SUBJECT: Forwards response to RAI re review of request for amend dtd 970929 for TS related to main steam line isolation signal setpoints.

Subject: Response to Request for Additional Information (RAI)
Rochester Gas & Electric Corporation
R.E. Ginna Nuclear Power Plant
Docket No. 50-244

Reference: Letter from G.S. Vissing, NRC, to R.C. Mecredy, RG&E, Subject: *Request for Additional Information - Review of Request for Amendment Dated September 29, 1997 - Change to the Technical Specification Related to the Main Steam Line Isolation Signal Setpoints (TAC No. M99702)*, dated April 3, 1998.

Response to RAI of April 3, 1998

Figure 8

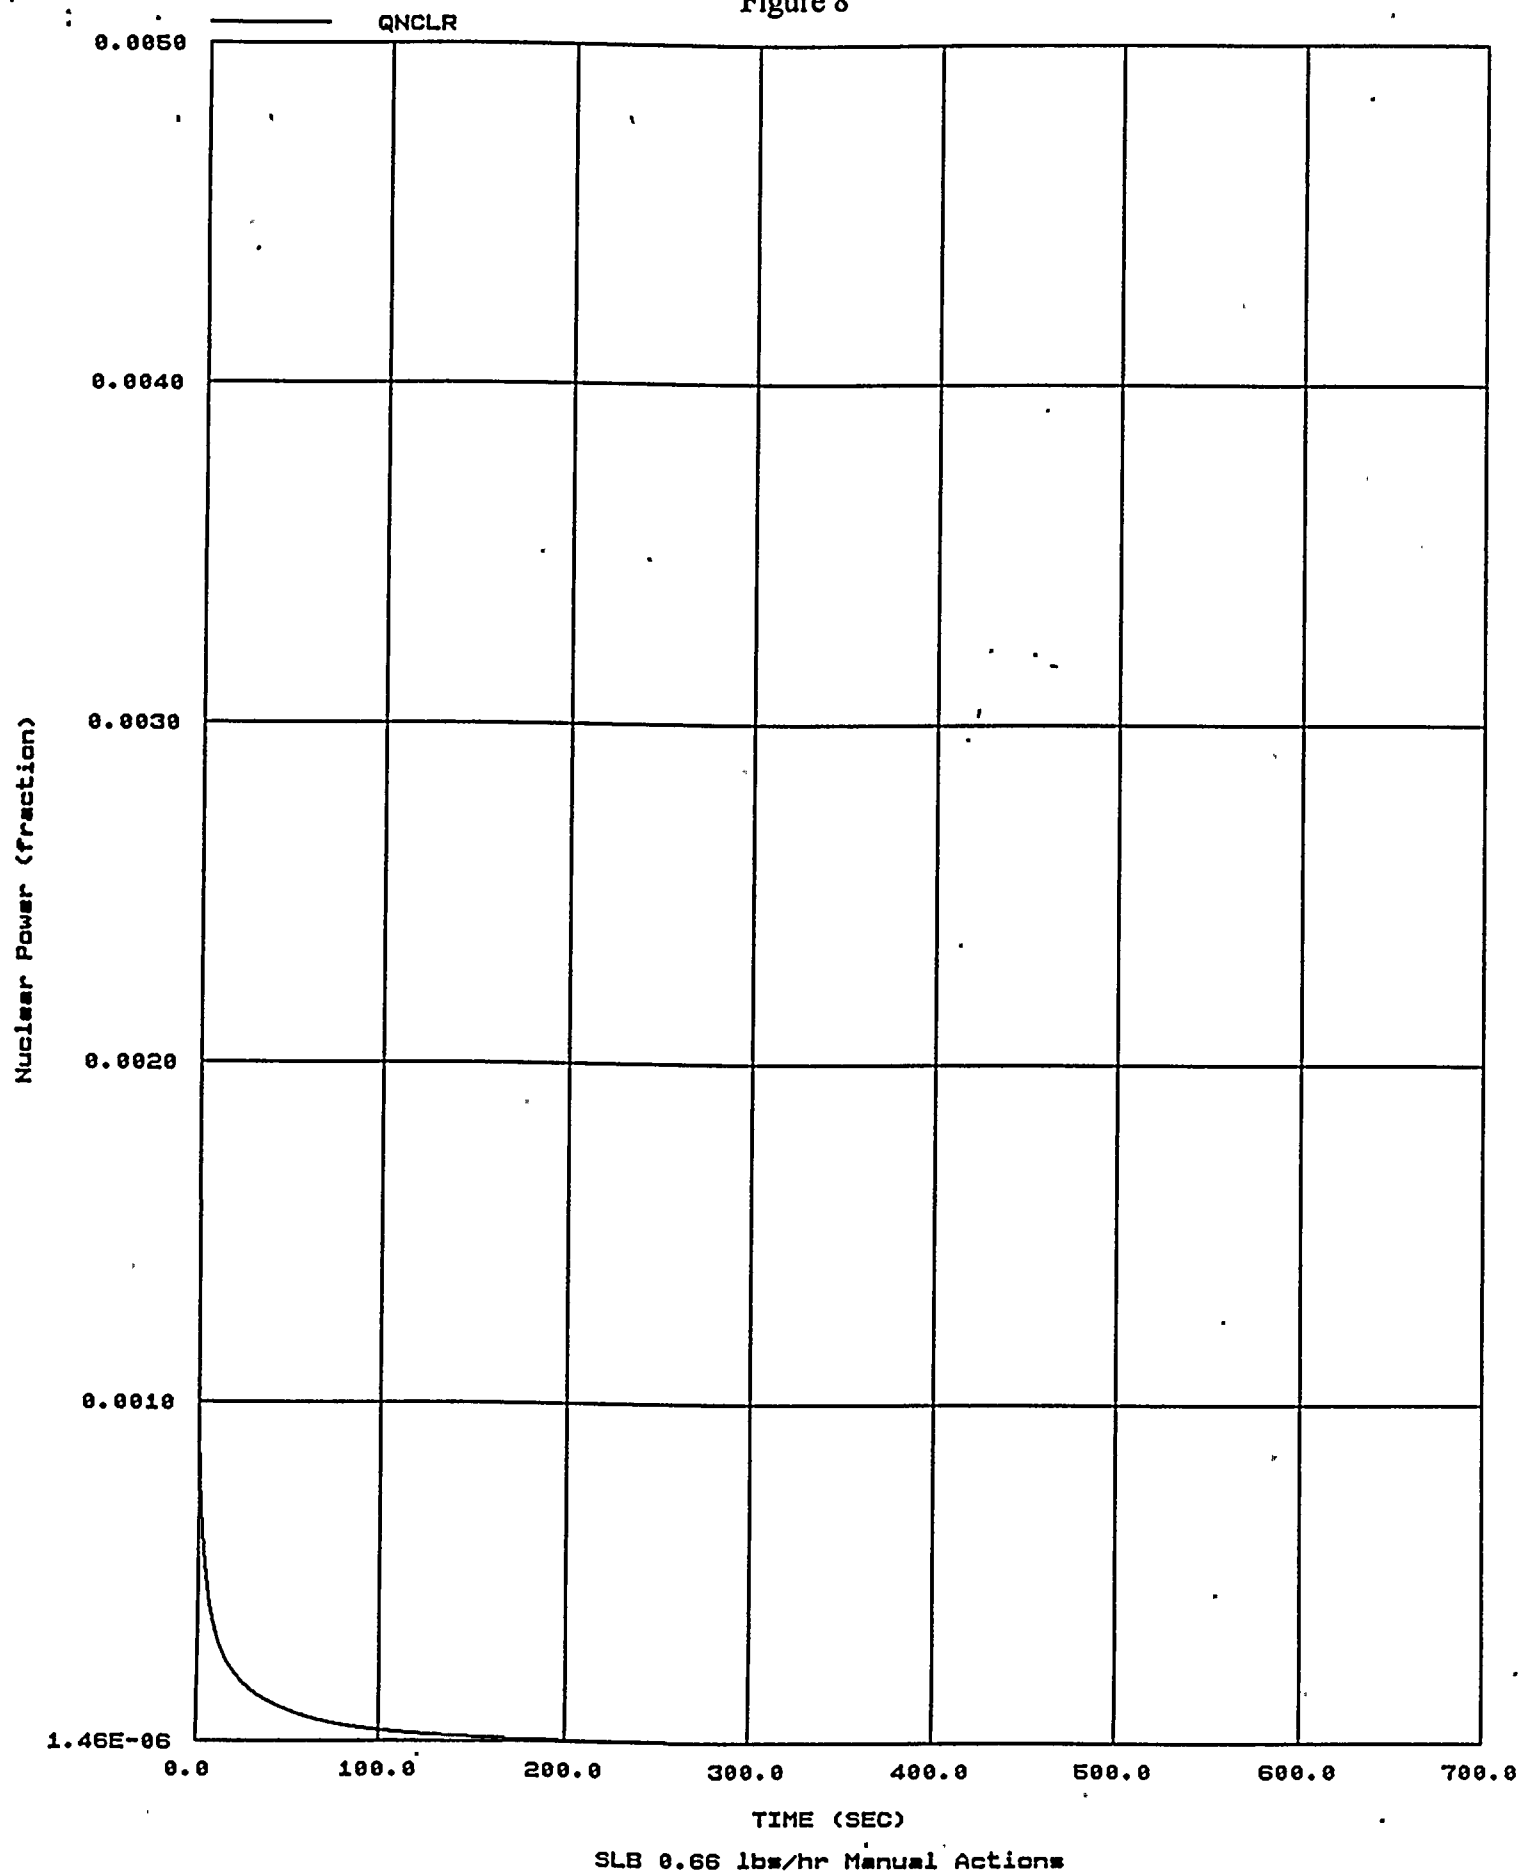
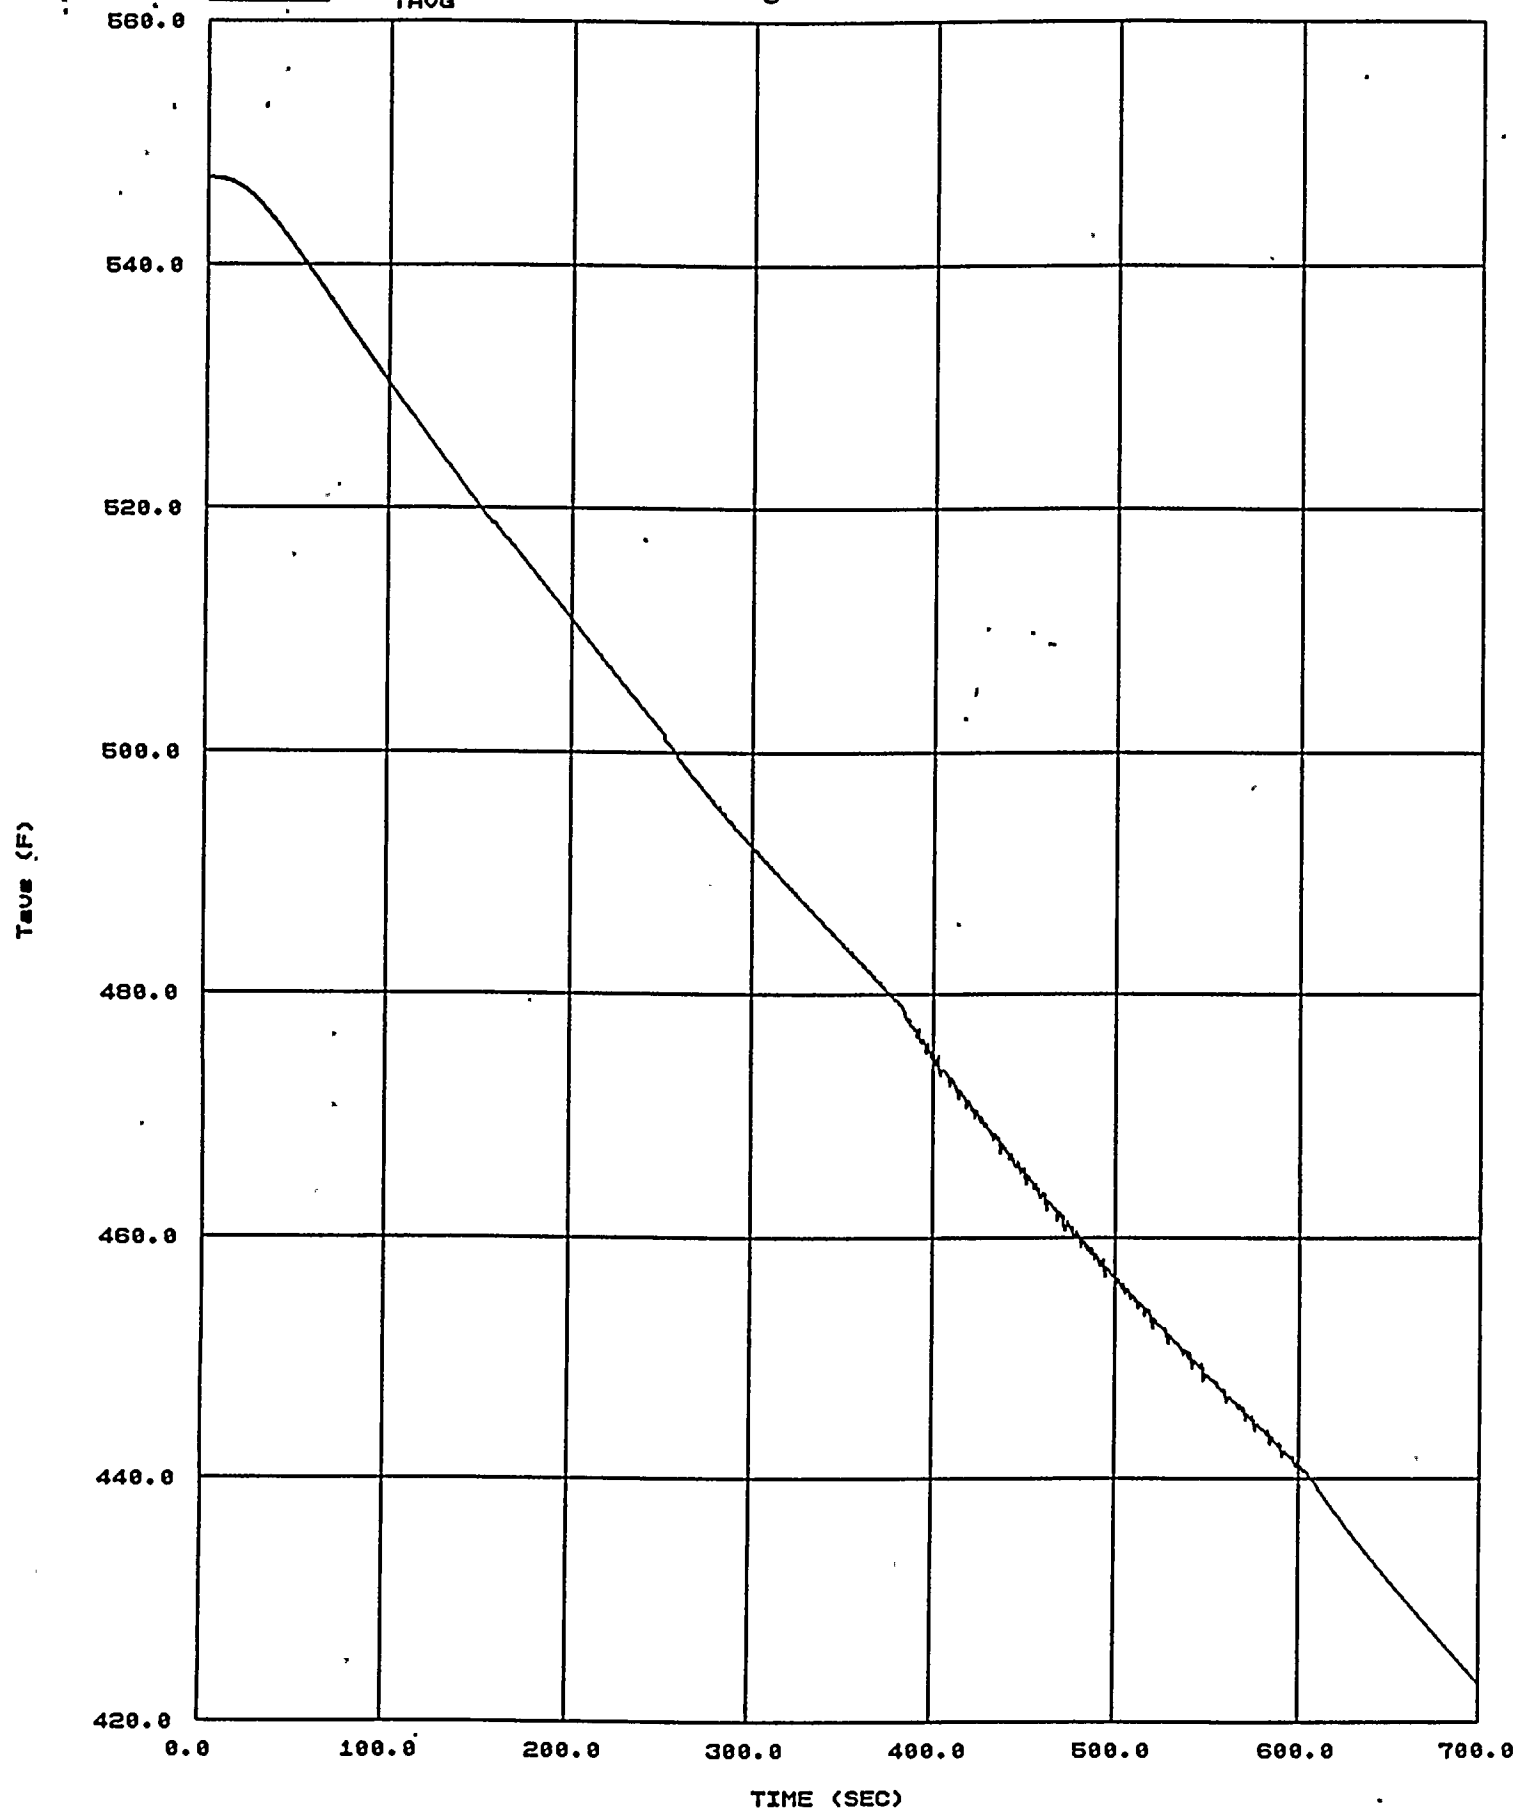
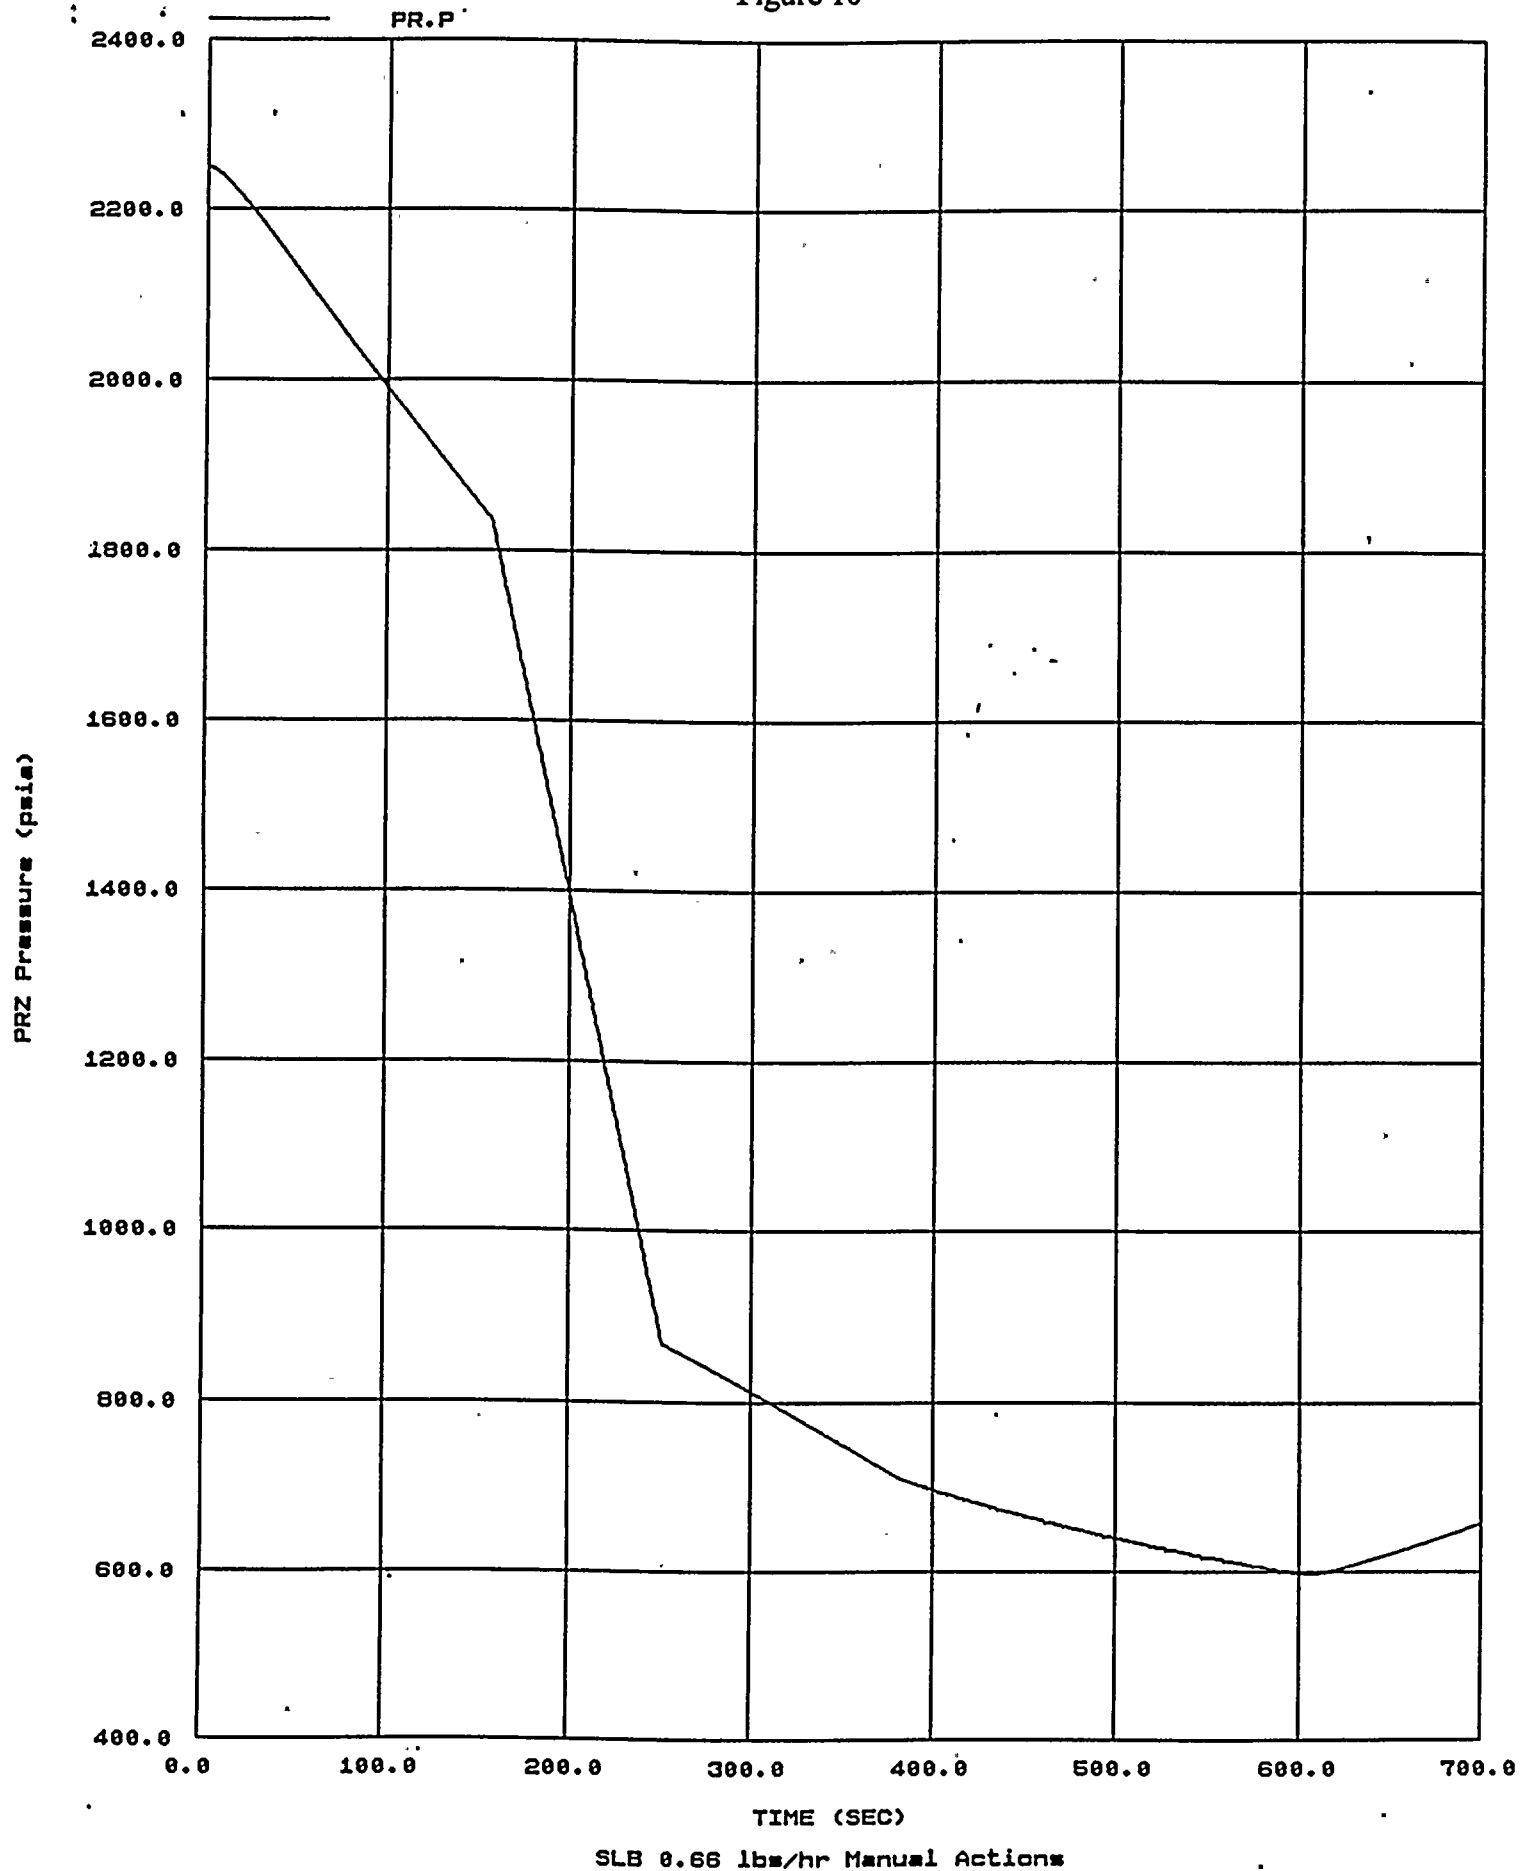
2. *Please provide the results of your reanalysis.*

Attached Figures 1 through 7 represent parameters from Case 5-O. Figures 8 through 14 represent parameters from the 0.66E6 lbm/hr steam line break in one steam generator described in the February 6, 1998 RG&E letter (hereafter referred to as Case SLB). A comparison of the parameters shows:

- a. Resulting nuclear power is less for Case SLB;
- b. Resulting RCS temperature reduction is less for Case SLB;
- c. Resulting pressurizer pressure reduction is less for Case SLB;
- d. Resulting steam generator pressure reduction is less for Case SLB;
- e. Steam generator mass trends illustrate the difference between a feedwater malfunction and a steam break;
- f. Total reactivity insertion is less for Case SLB but occurs over a longer time frame; and
- g. The rate of reactivity insertion is less for Case SLB.

In summary, the parameters indicate that the Case SLB is less severe than Case 5-O and that the limiting criteria with respect to the reactivity insertion rate is less than that for Case 5-O. Therefore, UFSAR Case 5-O remains bounding.
